# INNER WEST COUNCIL

## **SYDNEY METRO - ENVIRONMENTAL IMPACT ASSESSMENT**

Please find attached Inner West Council's submission on the Sydney Metro Chatswood to Sydenham Environmental Impact Statement.

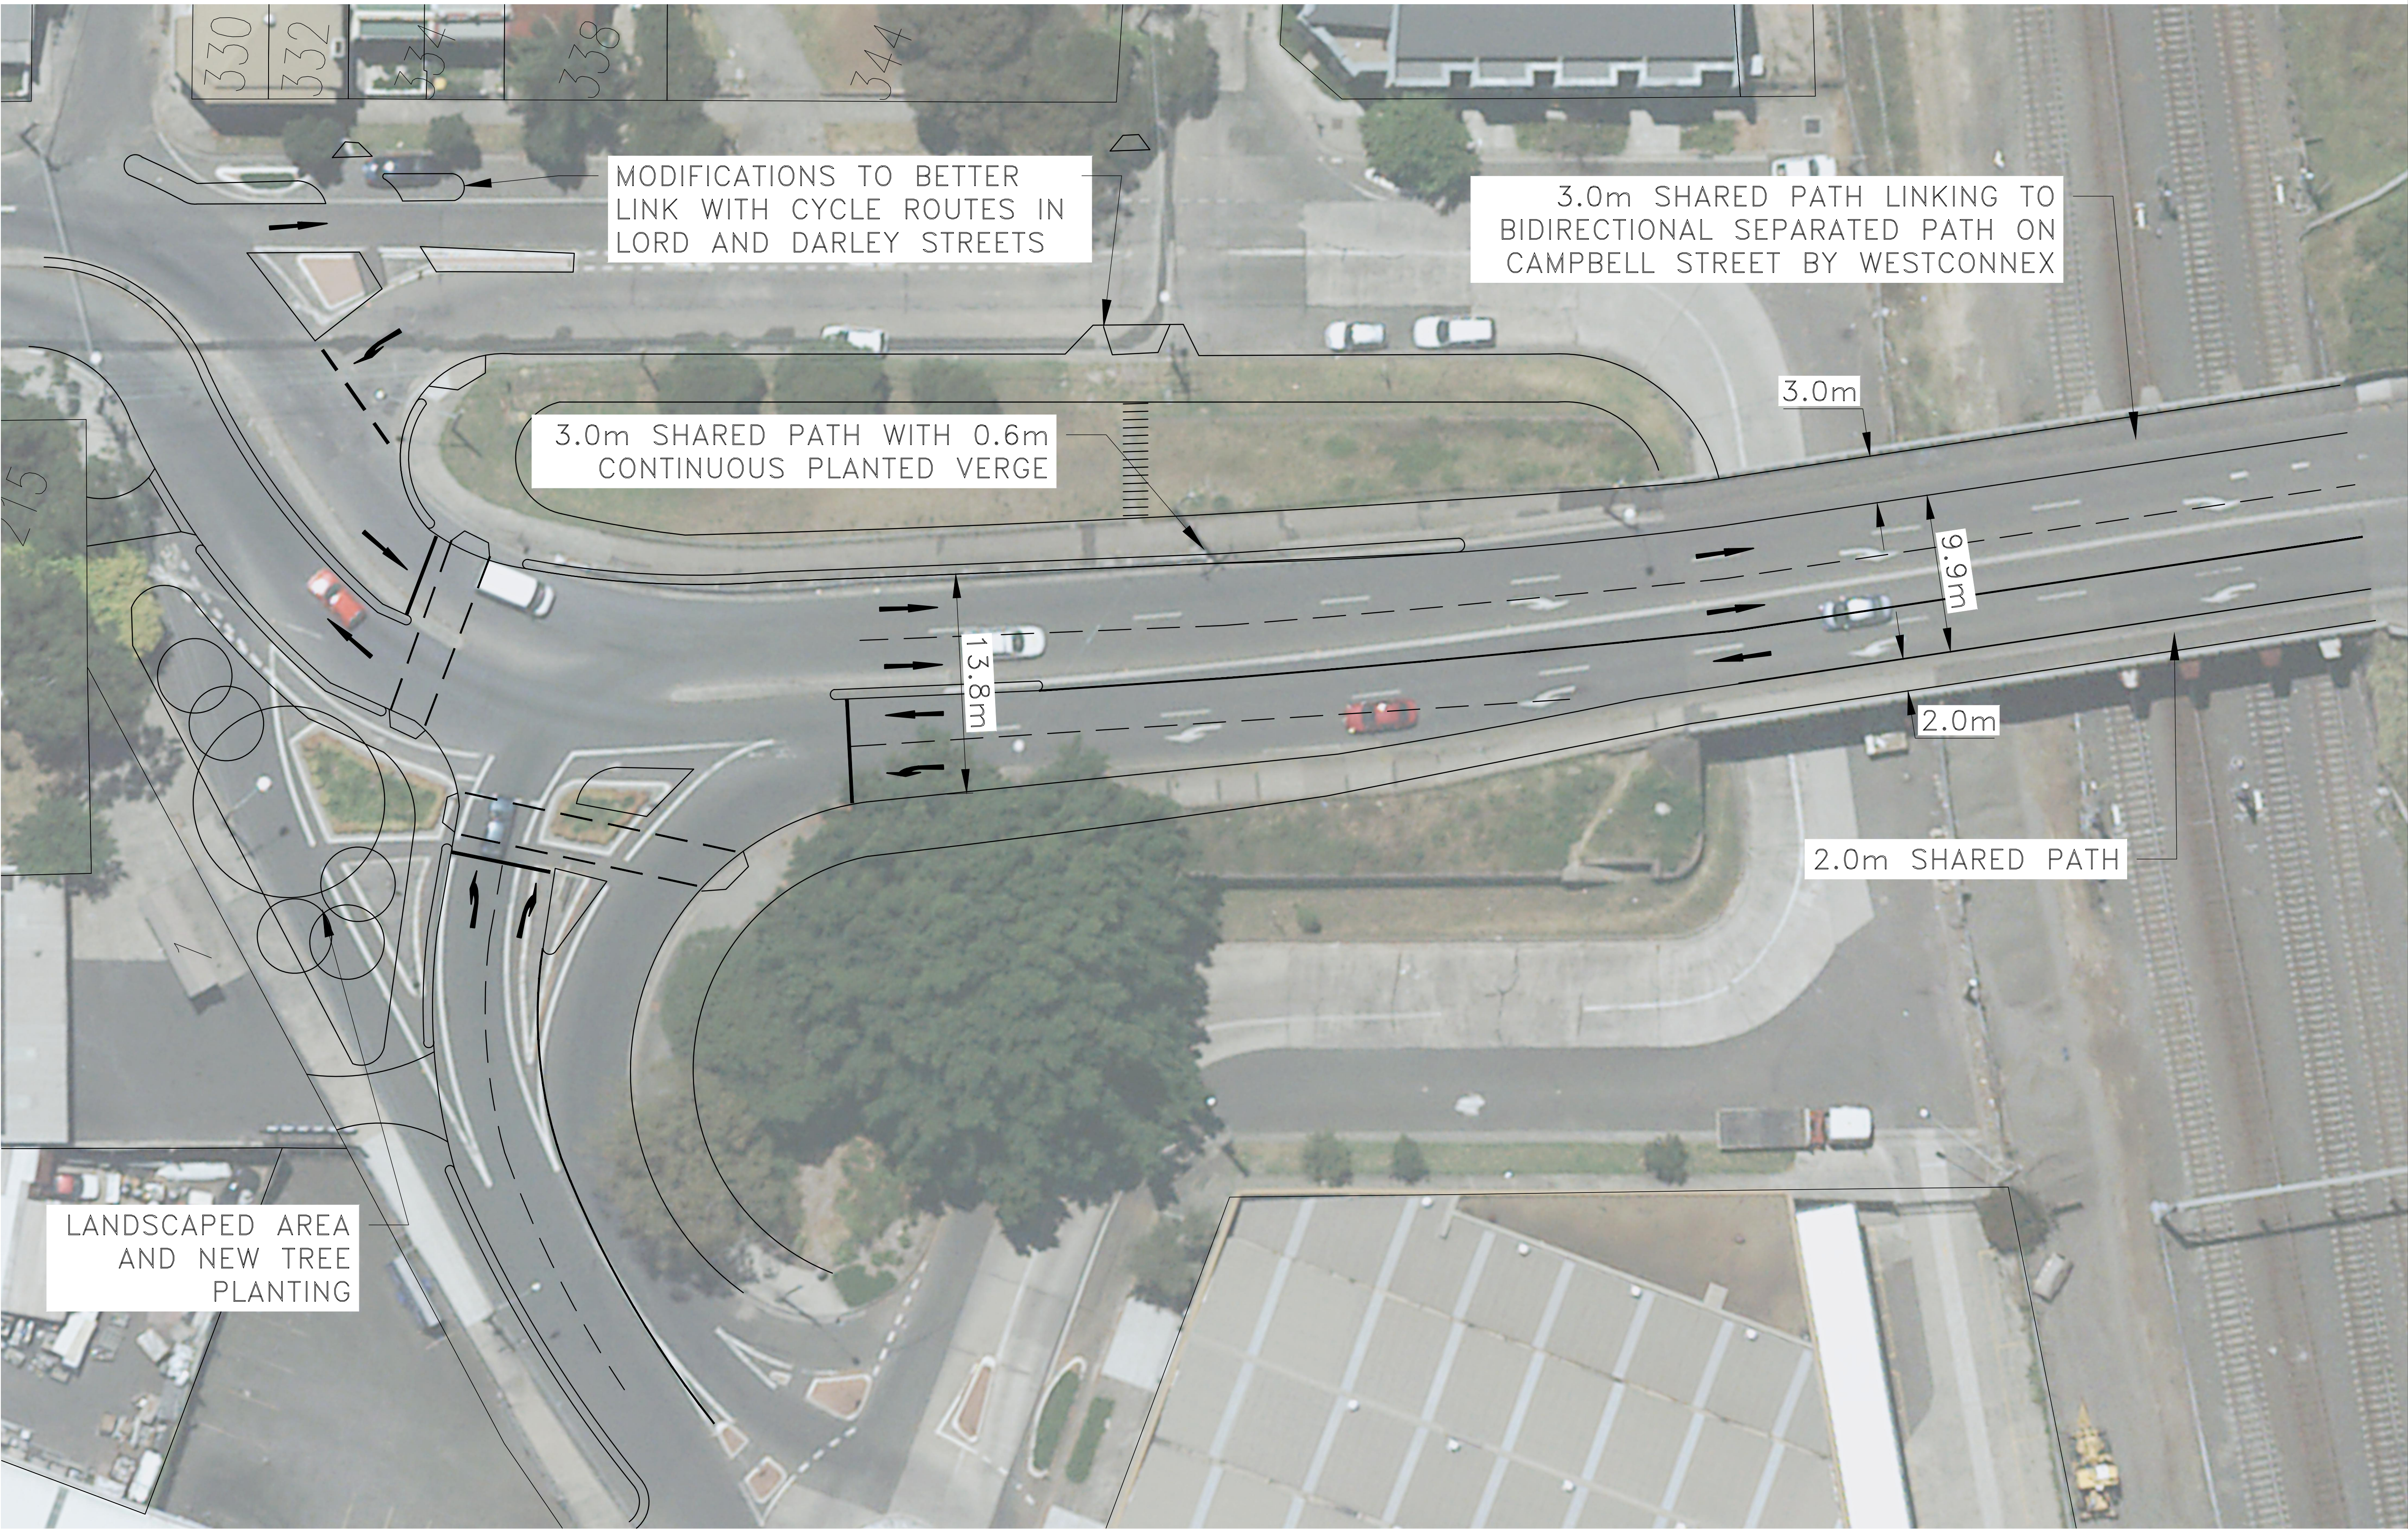
The proposed upgrade of the Edinburgh Road/Bedwin Road/Edgeware Road intersection shown in the EIS does not reflect Council's comments from previous meetings with Sydney Metro. In line with objectives of the NSW Long Term Transport Master Plan, the intersection must improve pedestrian priority when it is upgraded. The proposed arrangement with three crossing legs on the western side is not acceptable. An acceptable arrangement is suggested in the diagram provided in **Attachment 1** of this submission. Consideration also needs to be given to improving pedestrian and cyclist amenity at the intersection of Bedwin Road and Edgeware Road (south).

As part of the project, and in light of extra construction vehicle movements that are set to take place around Bedwin Road, improvements to Bedwin Road Bridge must be made in order to enable safe pedestrian and cycle movement. The bridge between Campbell Street and Edgeware Road currently has four lanes for traffic, a narrow and unsafe pedestrian footway and no provision for bicycles. It is an important missing connection in regional cycle routes. The works proposed for Campbell Street as part of the New M5 Project in the vicinity of the St Peters Interchange will place even greater importance on this cycle route. A dedicated cycleway is proposed along Campbell Street/Road from Bourke Street to Bedwin Road; Sydney Metro's mobilisation of construction activity along the rail corridor and beneath the bridge presents a unique opportunity to look at adding capacity to this bridge for dedicated cycle infrastructure. Being intrinsically linked to rail infrastructure and active transport would place this well within the scope of this project. This significant opportunity could be realised through cross-government collaboration with SMC.

In addition, construction of a proposed off-road cycleway connecting Edgware road with Sydenham Station adjacent to the proposed dive site should be undertaken as part of this project. This will connect to the existing covered Sydney Water Eastern Channel at the Sydenham detention basin with a link into Garden Street. The existing cycle route travels along roads with a high percentage of heavy vehicles and this is highly likely to be severely impacted by the project with many additional heavy vehicle movements; as such this should take place, as far as practicable, prior to construction commencing. Council will be investigating options for this route in 2016/2017.
